# RFP 2024-01 REQUEST FOR PROPOSALS FOR THE BUILD-OUT OF A NEW ANIMAL SHELTER LOCATED AT 427 BEACH ROAD IN HAVERSTRAW, NY ISSUED JULY 25, 2024

To:	All Potential Proposers
From:	Rockland Green
Subject:	Addendum Number 3
Project:	Build-Out of a New Animal Shelter Located at 427 Beach Road in Haverstraw, NY
RFP No.:	RFP 2024-01
Date:	September 30, 2024

(2) new Civil Contract Drawings and revised Civil Contract Drawings to reflect that, in lieu of a new pump station, the existing (undersized) pump station on Site can be removed and replaced with a new (gravity) sanitary sewer lateral to Beach Road, Haverstraw, NY.

PROJECT LOCATION: HAVERSTRAW, NEW YORK CLIENT: ROCKLAND GREEN DRAWING TITLE: SITE REMOVALS PLAN

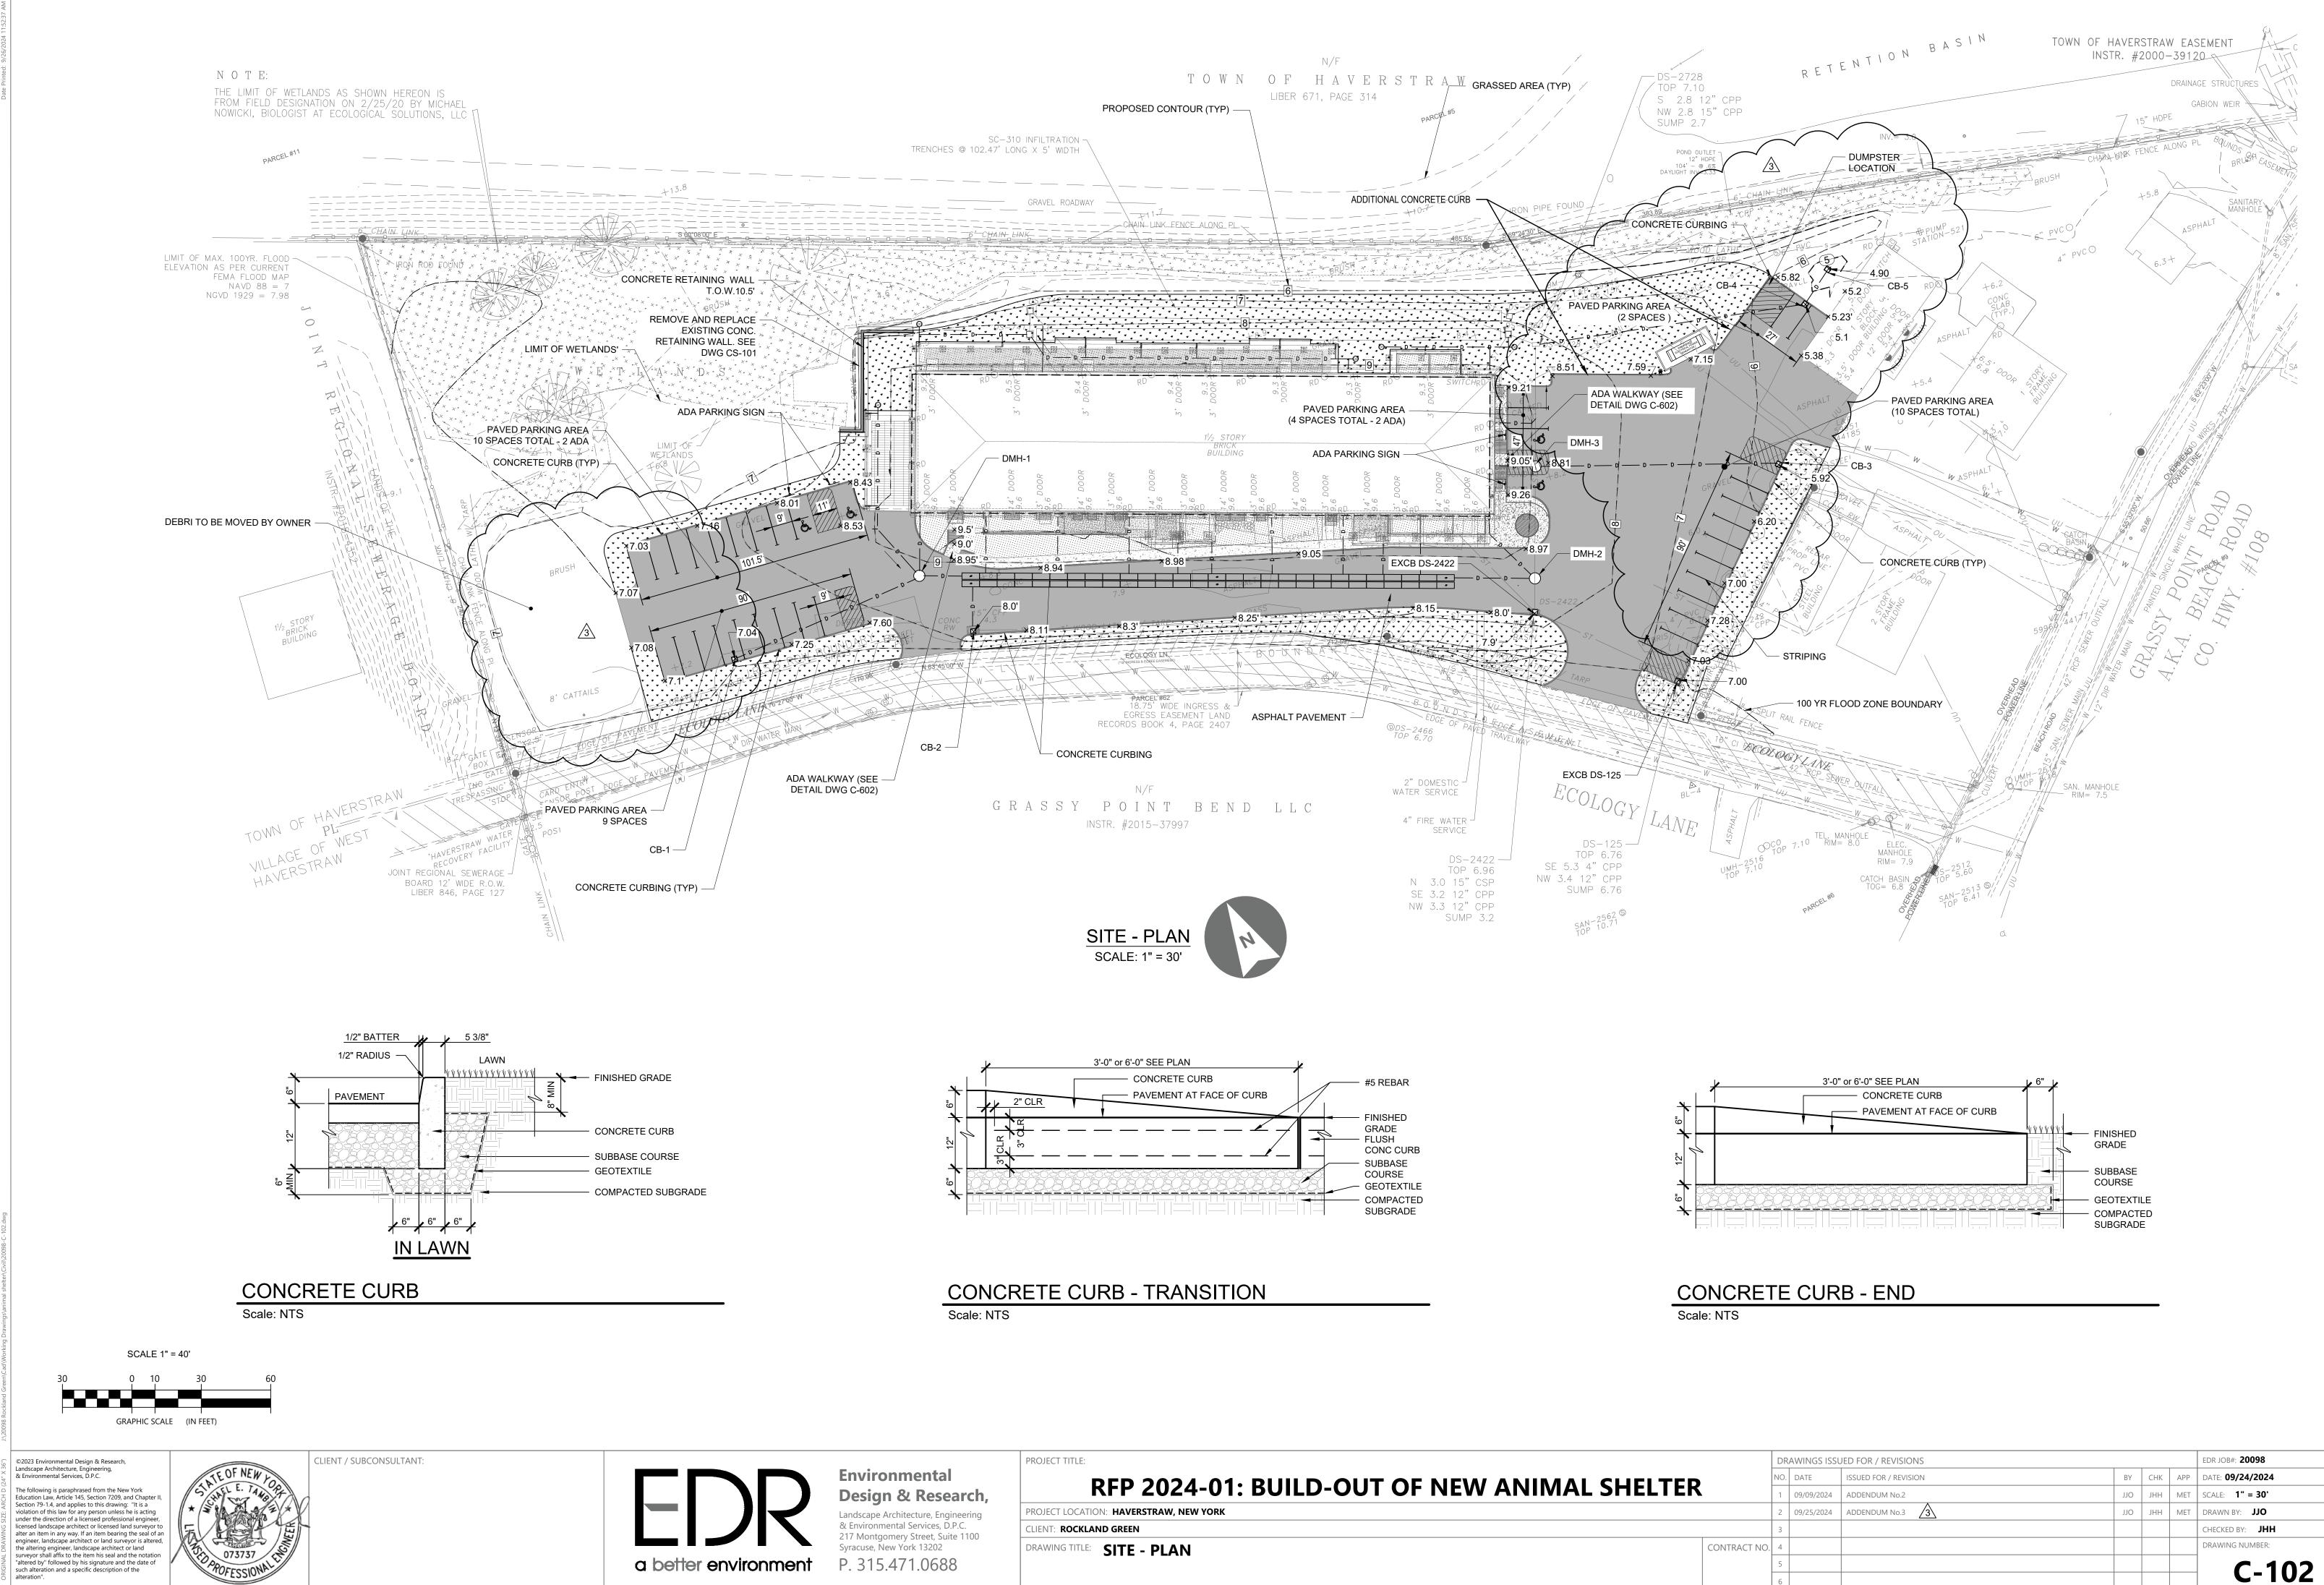
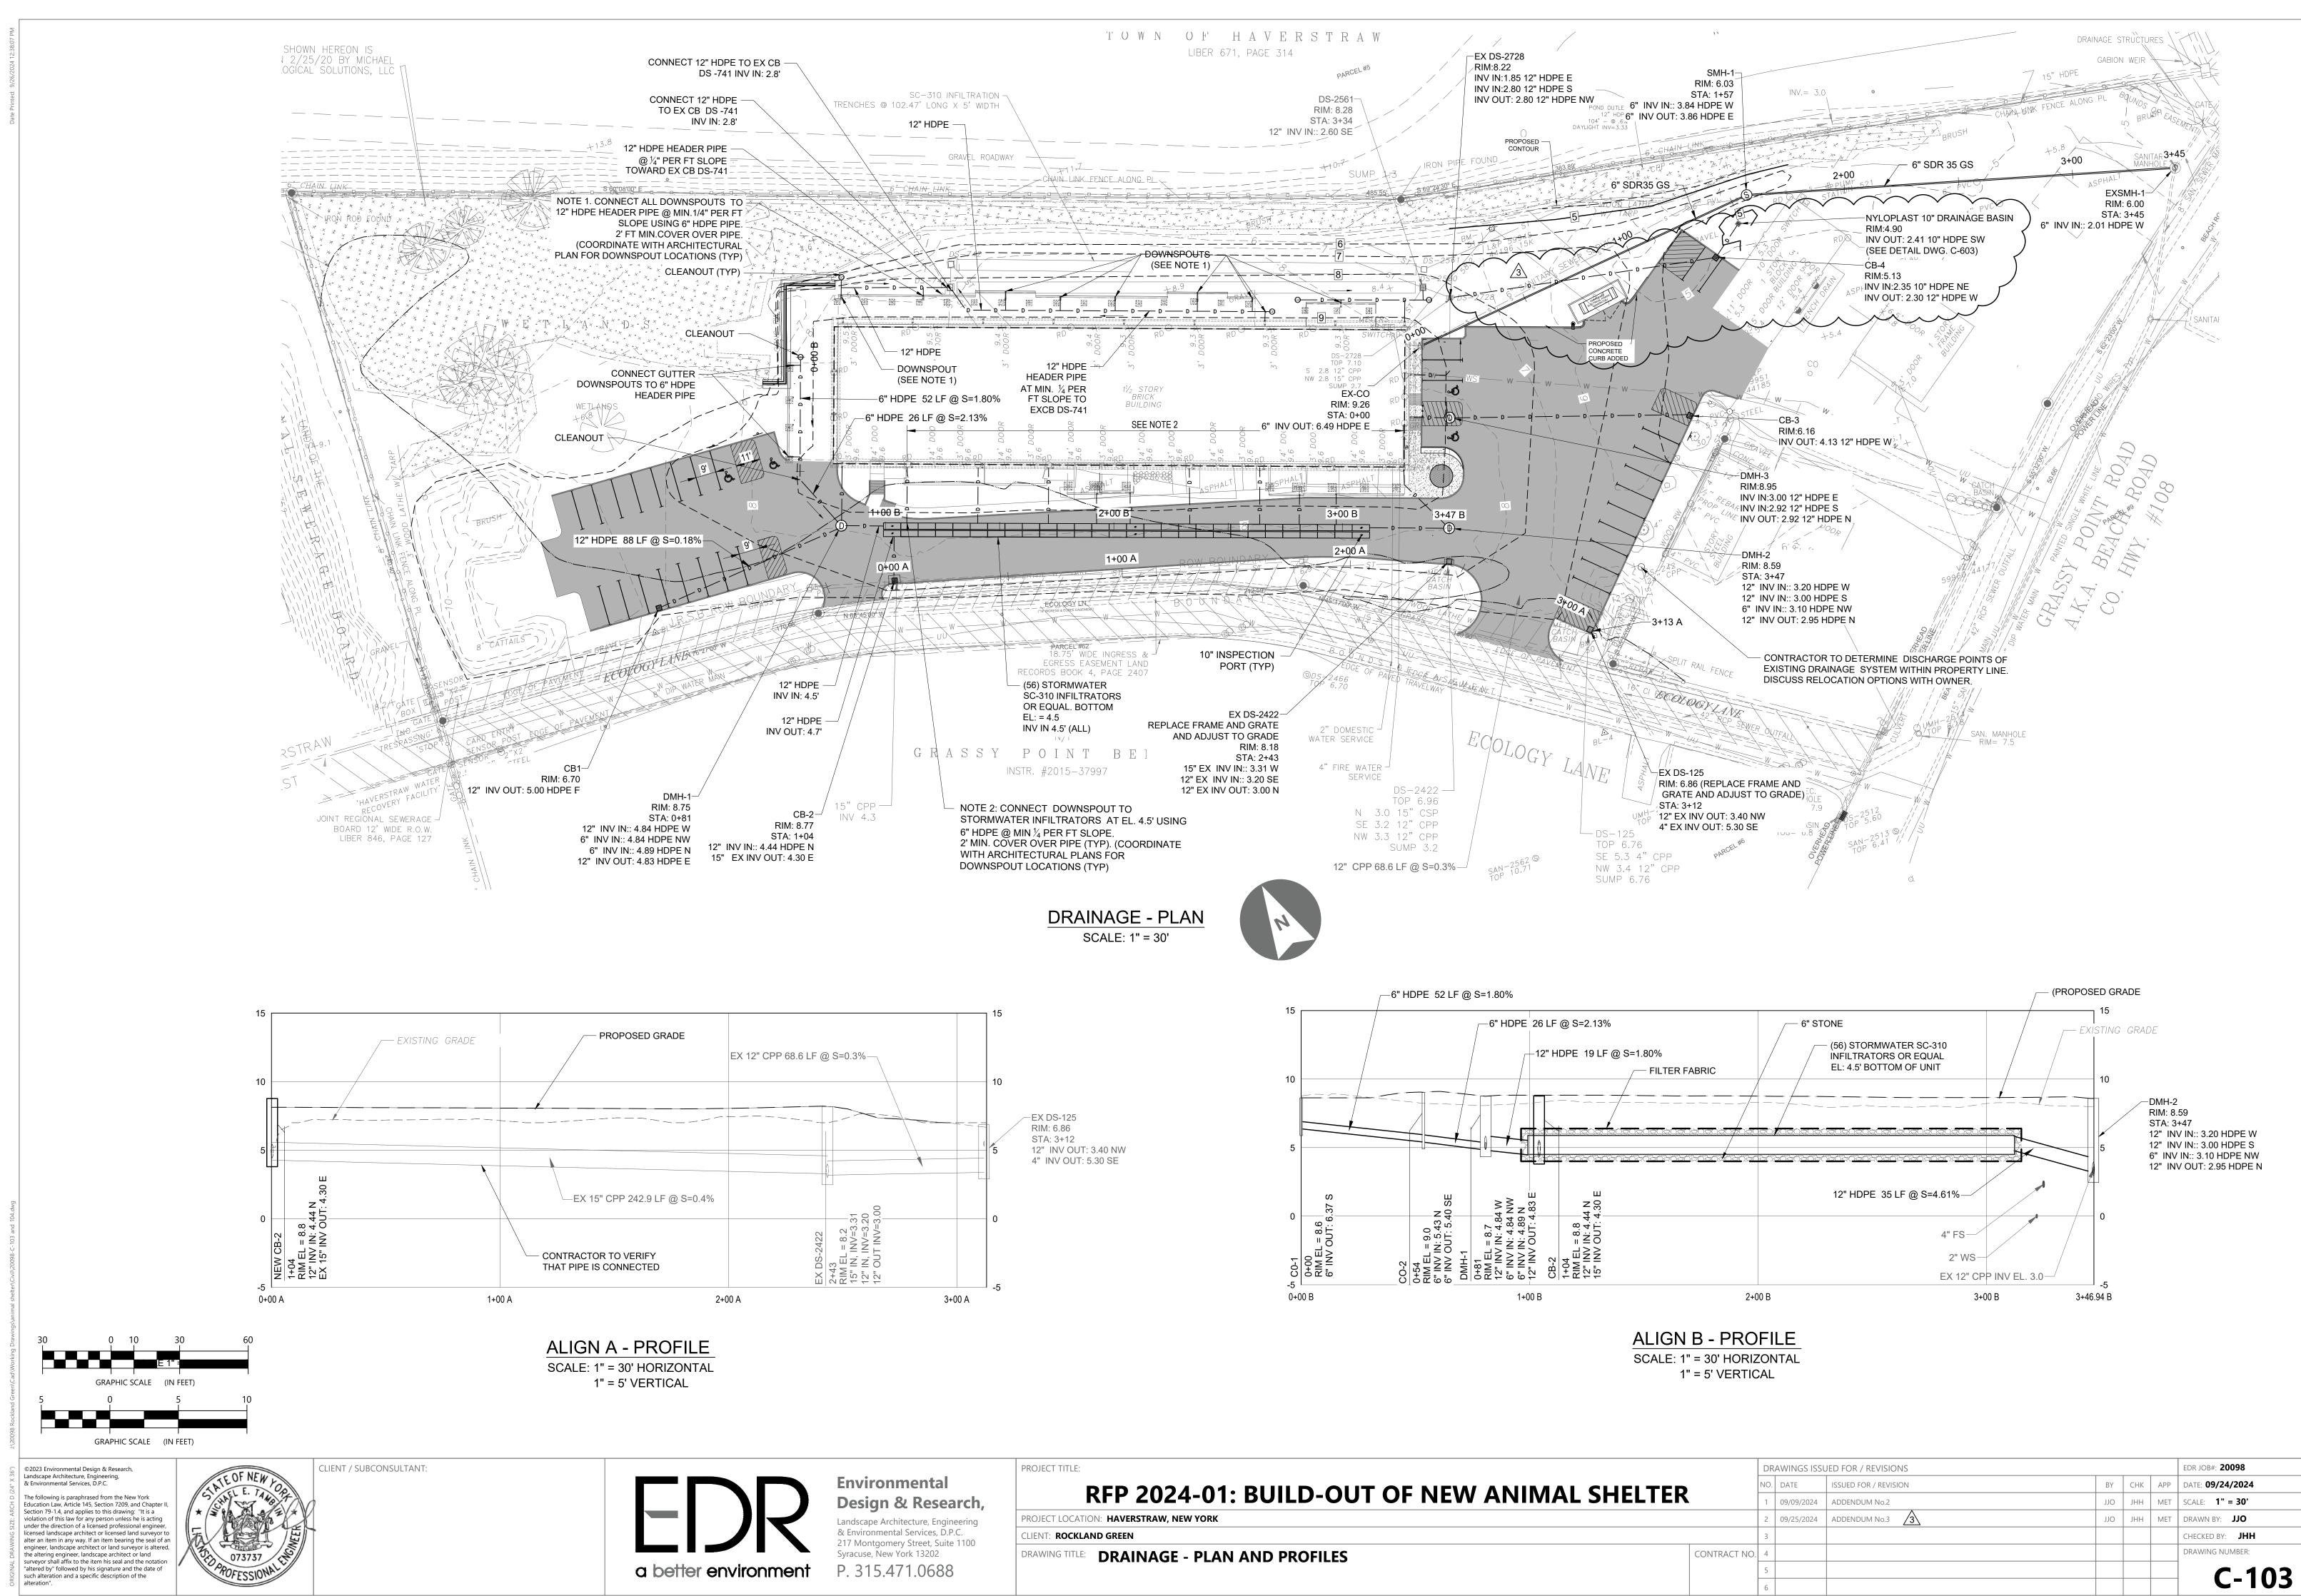
- CG-001 Notes, Abbreviations (Revised for Contract Drawing list and abbreviations)
- C-101 Site Removal Plans (Revised to show removal of existing lateral)
- C-102 Site Plan (Revised with added details)
- C-103 Drainage Plan and Profile (New Contract Drawing to show addition of drain and pipe call for additional soil cover over the new sewer lateral revised grading required additional drainage feature)
- C-104 Sewer Connection Plan and Profile (New Contract Drawing to show new sewer lateral from the building to Beach Road frontage one new manhole and tie-in to existing manhole)
- C-603 Details (Revised to include an additional detail)
